## Marine Notice No. 9 of 2017

EPIRB Information Bulletin:  
McMurdo Smartfind EPIRB – (all versions)  
Kannad Marine EPIRB – Sport/Sport Pro/Sport Pro +

# Information BULLETIN

**Issue No:** MG016B **Date:** 18<sup>th</sup> February 2017

## Top dome replacement

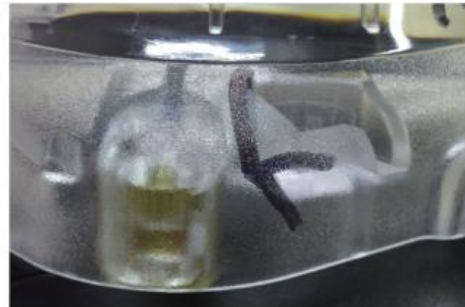
It has come to our attention that the top dome under certain circumstances may begin to show signs of localised craze cracking. Small cracks may appear to be radiating out from the three over moulded screw inserts.

The cracking area is outside of the waterproof seal (main O ring seal) in a wet zone which is a self-draining cavity. As such, any cracking in this area will not compromise the waterproof body seal in anyway, or significantly weaken the overall integrity of the EPIRB.

1. Clearly, any cracking is undesirable and unsightly and our recommendation is that the EPIRB should be subject to rectification work at earliest opportunity.
2. Should you have any concern with regarding the condition of your EPIRB you are invited in the first instance to contact the McMurdo customer support team for advice.
3. If the EPIRB is in warranty period, complete an RMA application using the online form:-
